BCA ASSESSMENT REPORT

ISSUED FOR DEVELOPMENT APPLICATION

Residential Flat Building

5 Adina Road, Curl Curl NSW 2096

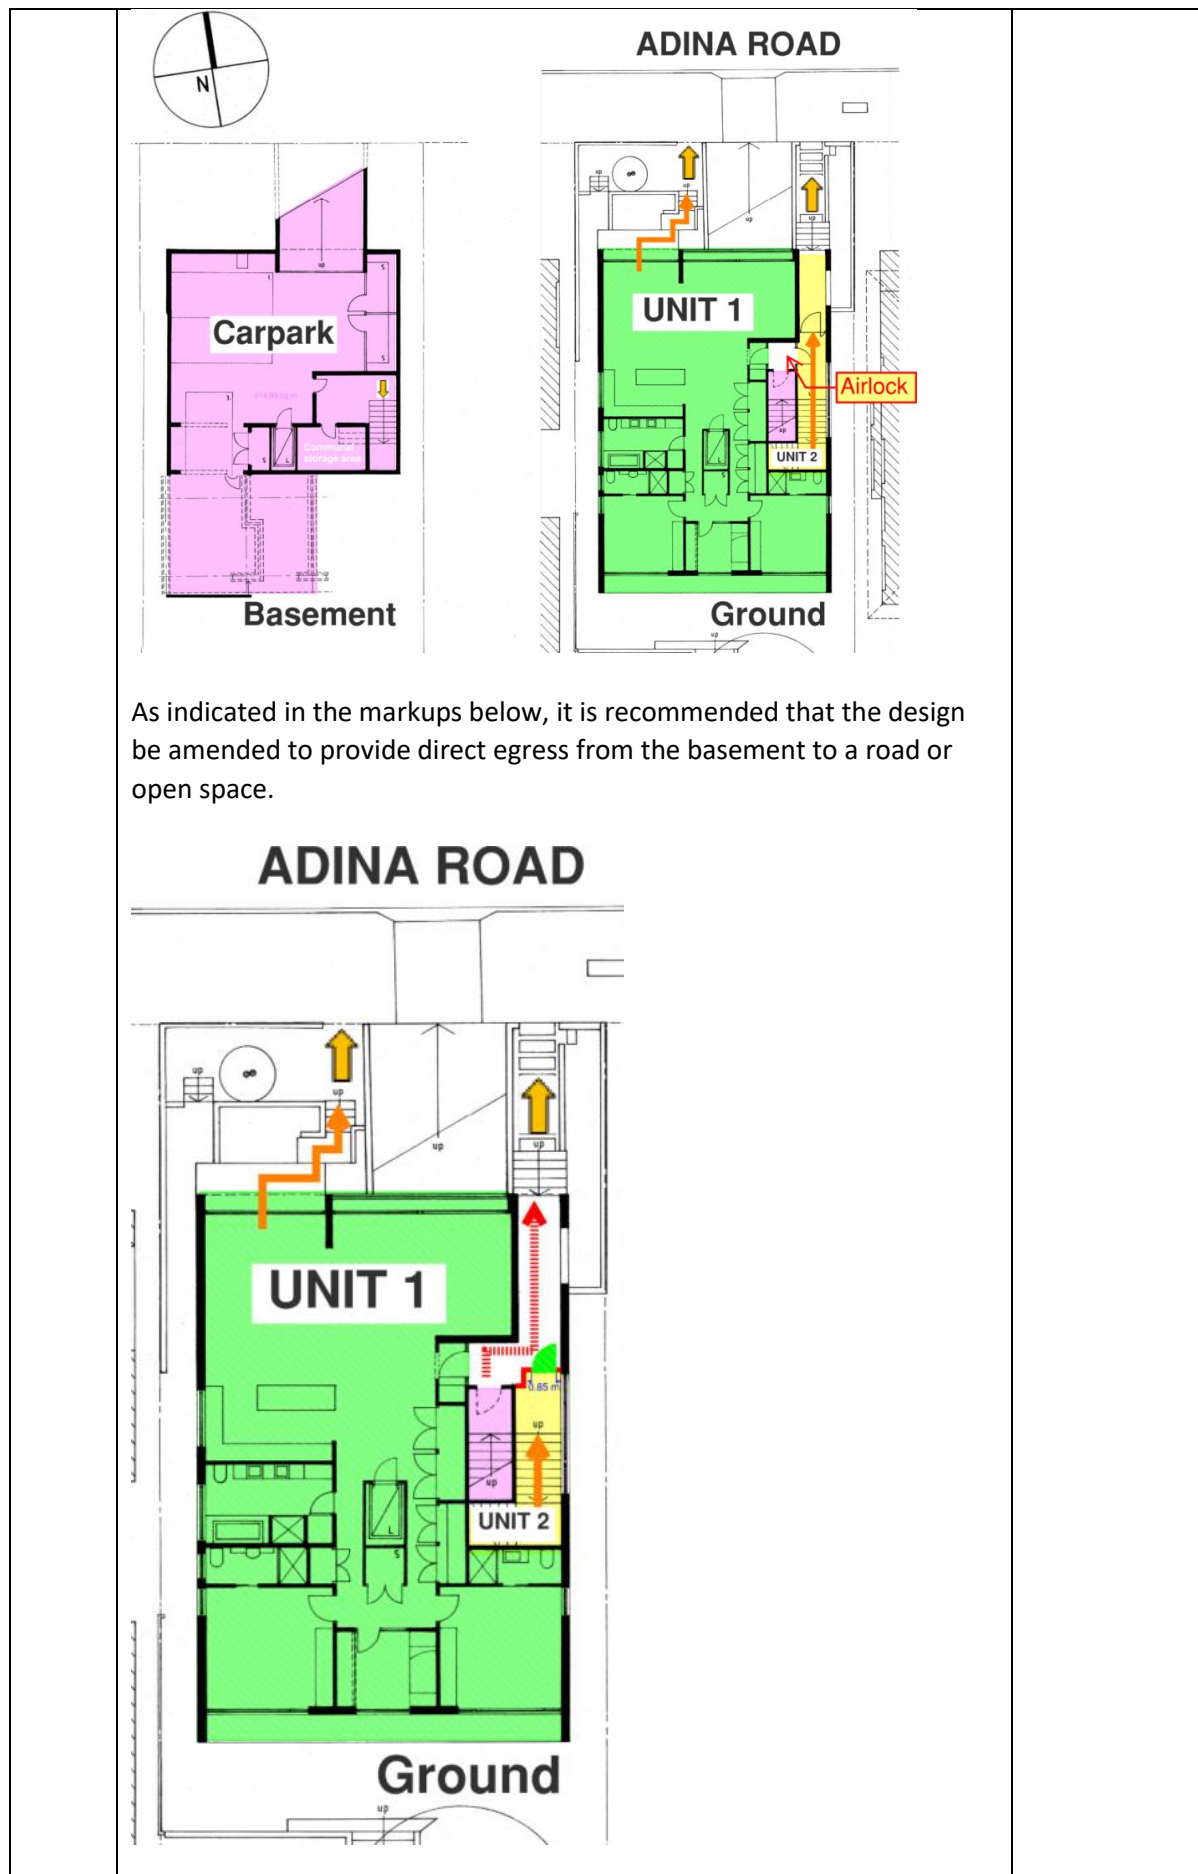
<p><u>Possible Performance Solution: Level 1 glazed floor</u> The existing horizontal glazed panel located in the living area adjacent to the stairway on Level 1 should achieve an FRL of 30/30/30 as per S5C21, or be subject to a separate performance solution report prepared by a fire engineer.</p> 		
--	---	--	--

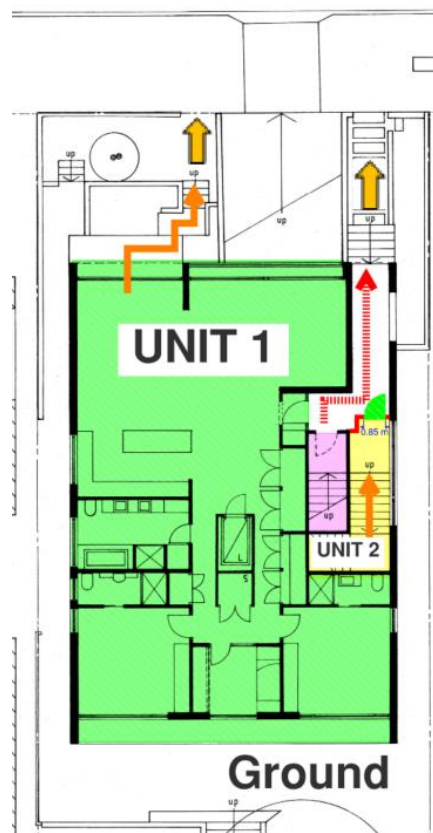
Basement Carpark

In the current design, occupants traveling from the basement to the ground-level airlock must pass through Unit 1 or Unit 2 to exit the building. This approach:

- Limits the immediate escape route available to occupants, potentially delaying evacuations,
- Increases the likelihood of exposure to smoke, heat, and other hazards, which could impede safe evacuation.

As shown in the markups below, it is recommended that the design be amended to provide an direct egress route from the basement to a road or open space.
